24/00560/HYB – LAND SOUTH OF STATION ROAD, MARKET BOSWORTH

ADC Infrastructure Limited are commissioned by the applicant, Miller Homes, to provide transport and highways advice in support of a hybrid planning application for the construction of 138 residential dwellings and 0.55ha of employment use on land to the south of Station Road in Market Bosworth. The planning application was supported by a Transport Assessment and Travel Plans.

This letter has therefore been produced to present the updated vehicle tracking assessment and traffic calming features proposed to ensure suitable design speeds throughout the development.

Notes

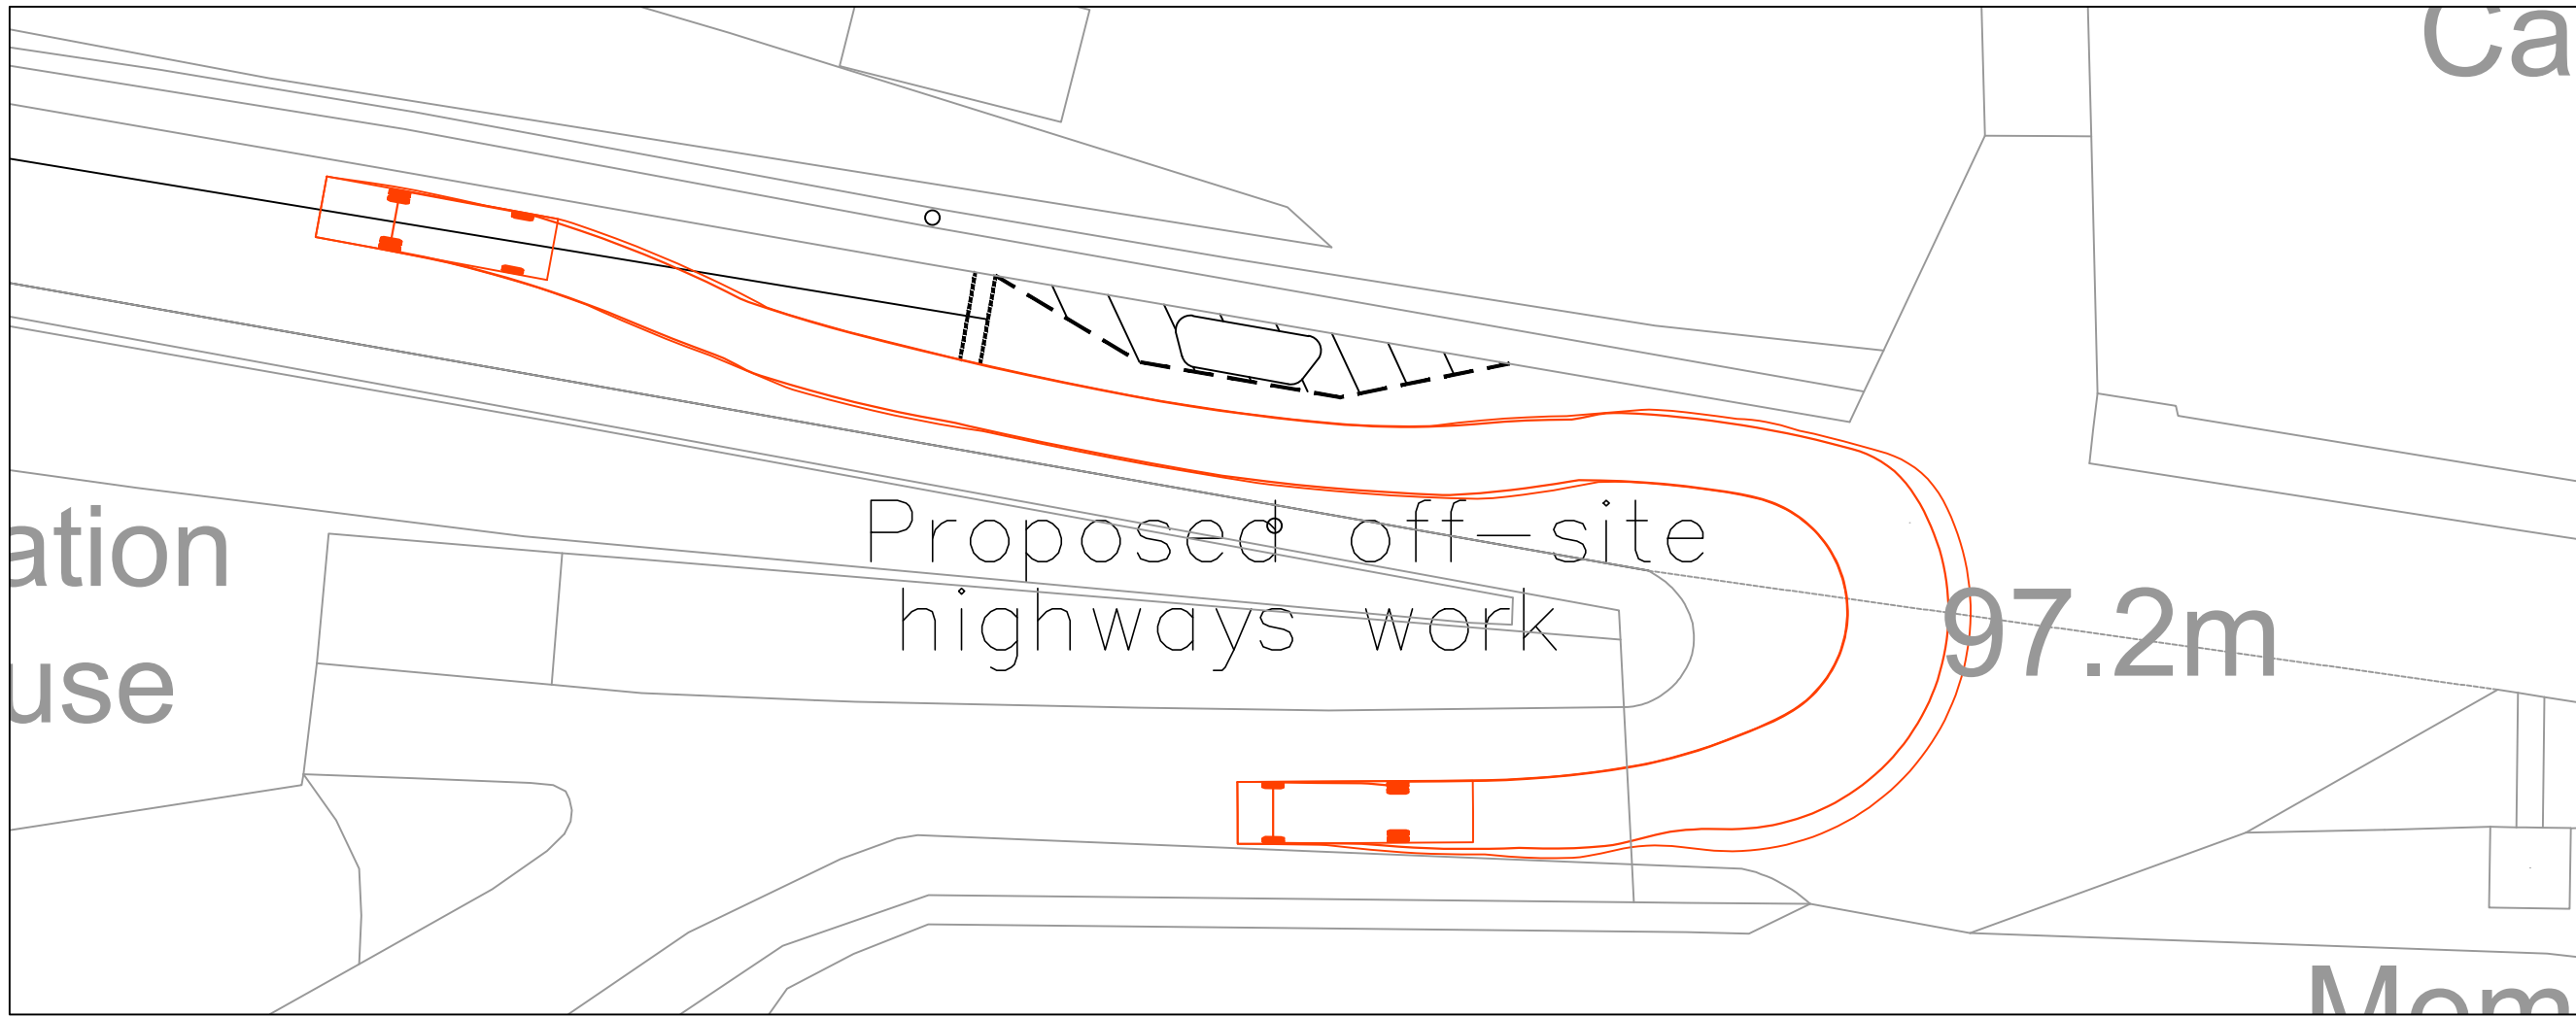
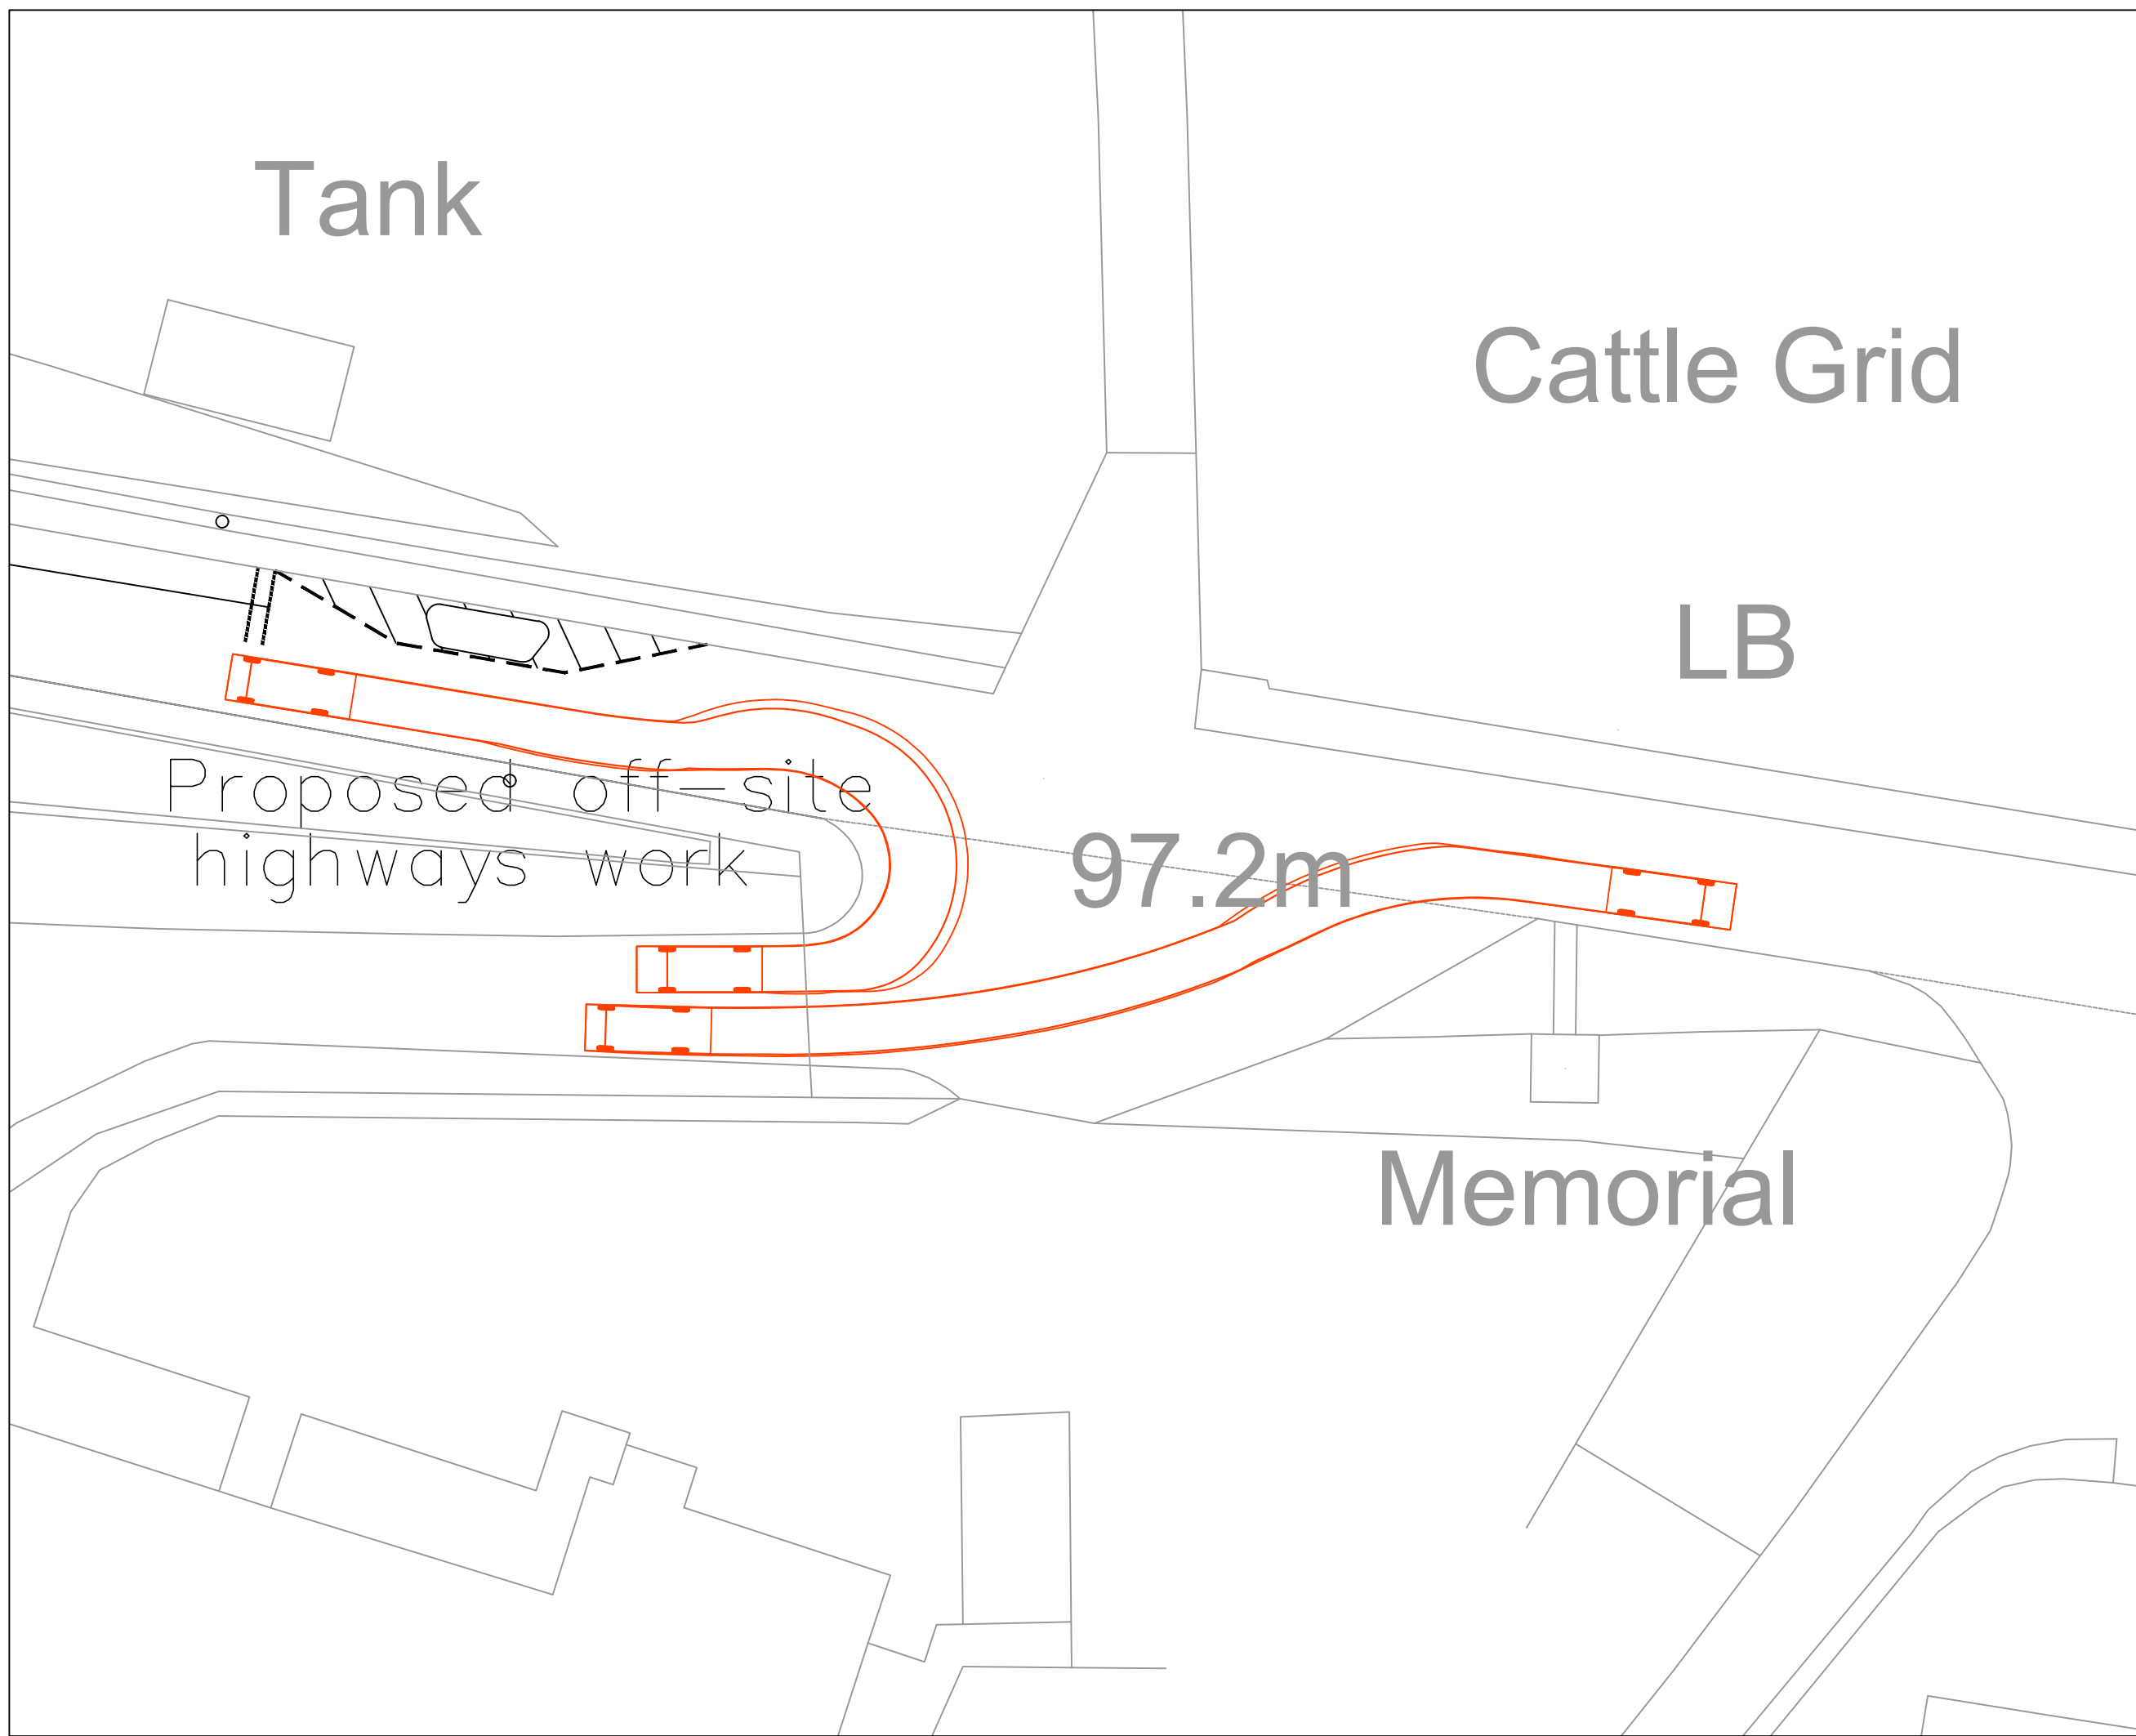
- Turning for a refuse vehicle has been shown, however the specification including the dimensions of the vehicle should be clarified and in line with the Swept Path Analysis guidance within the LHDG. This could be shorter than the 11.2m stated within the LHDG.

- The visibility splay looks to go over a tiny bit of third party land
- Changes will be needed to the swept path for refuse vehicles – it looked like the wrong size of vehicle had been used. This might affect the road layout and plot positions
- Traffic calming needed improving
- There remains an issue with the railway station access

Vehicle tracking of an 11.2m refuse vehicle has been undertaken. The vehicle tracking assessment is shown in **Drawing ADC3326-DR-005-P6** and demonstrates that the design vehicle can access, turn using the turning heads provided and exit again onto Station Road in a forward gear.

The drawing also demonstrates that the refuse vehicle can travel in both directions on the bends in the eastern parts of the development whilst opposed by a large car. As a result, the development layout is suitable to serve refuse and servicing vehicles.
